**CITY OF SEATTLE
ANALYSIS AND DECISION OF THE DIRECTOR OF
THE DEPARTMENT OF PLANNING AND DEVELOPMENT**

Application Number: 3003455
Address: 6801 Greenwood Avenue North
Applicant Name Chris Snell for of the Snell Partnership

Land Use Application to establish use for future construction of a four-story building containing 4,404 sq. ft. of retail at ground level and 51 residential units above. Parking for 73 vehicles to be provided in a partially above and partially below grade garage. Project includes 12,000 cubic yards of grading. Existing structures to be removed.

First DRB Meeting – January 12, 2006

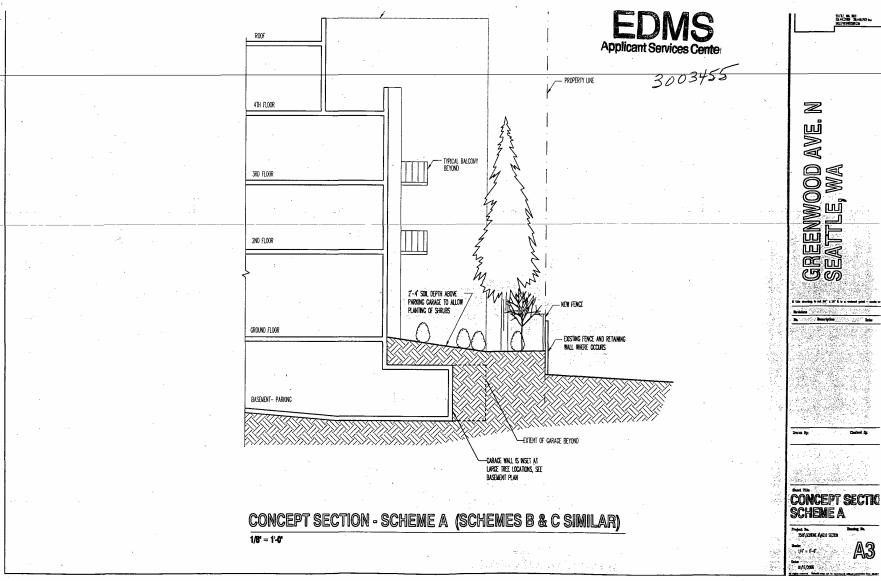
Of the three bulking schemes presented, Scheme A was preferred in its approach to fourth floor setbacks from the west. The Board felt the top floor as viewed from ground level from the west should "disappear" as much as possible. Setbacks of the top floor should average 32 feet from the west property line. Lot coverage for the fourth floor should not exceed 64%. A departure for increased lot coverage on floors two and three would be entertained by the Board for a scheme with increased setbacks on the fourth floor.

- Setbacks and modulation of the west façade, similar to those shown in Scheme A:
 - A suggested depth for these setbacks was 10 feet minimum and an average 18 feet across the west façade.
 - No cornice line or other heavy expression of the top edge of the building should be incorporated on the west side.

- Whether building setbacks at the fourth floor would be necessary on the north or south sides of the proposal:
 - The Board opted not to incorporate this into the priority guidelines.
- The Board did not think additional setback of the fourth floor from those below it is necessary on the eastern façade.
- Landscaping elements along the west property line should be used as screening and buffering for properties immediately to the west.
- In order for this to be viably accomplished it is necessary to preserve planting area and depth in the western lot area.
- Both above and below grade structures should be setback at least five feet from the west property line.
- Subterranean structures in building setbacks to the west and to the north and south must have a minimum of four feet of soil cover.
